I am Chief Flood Warden for Trowbridge and am writing because of serious concerns relating to the above application.

The application itself has already been rejected by the LPA, although consent was granted for access only at appeal inquiry.

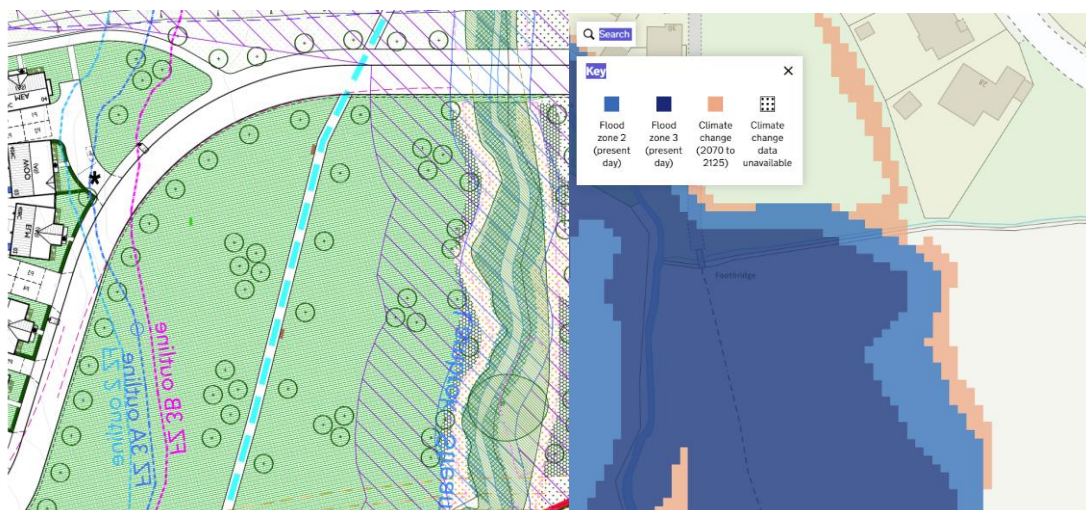
The latest, reserved matters application, not only omits any form of attenuation to the North of the proposed site, threatening the current built form, but ignores additional developments already underway. Furthermore, the length of the bridge has been reduced to around 50m, which means that it terminates **within** FZ3b. This is the only access road other than an access for emergency vehicles which has been mandated by Examination to be bollarded and locked at all times. The current proposal also places the curtilage of properties and associated infrastructure within FZ2.

If this alone were not concerning, when the current flood map for planning is interrogated, the proposal has clearly been framed with out-of-date data. The current fluvial flood zones are far more extensive than developers claim, and appear to include the entirety of one of the uphill attenuation features **within FZ3!**

I have attached a "quick and dirty" pair of images showing the proposed bridge and access from the reserved matters application along with the same area taken from the current flood map for planning. Although there is no common scale, the location and position of the footpath is a diagnostic aid.
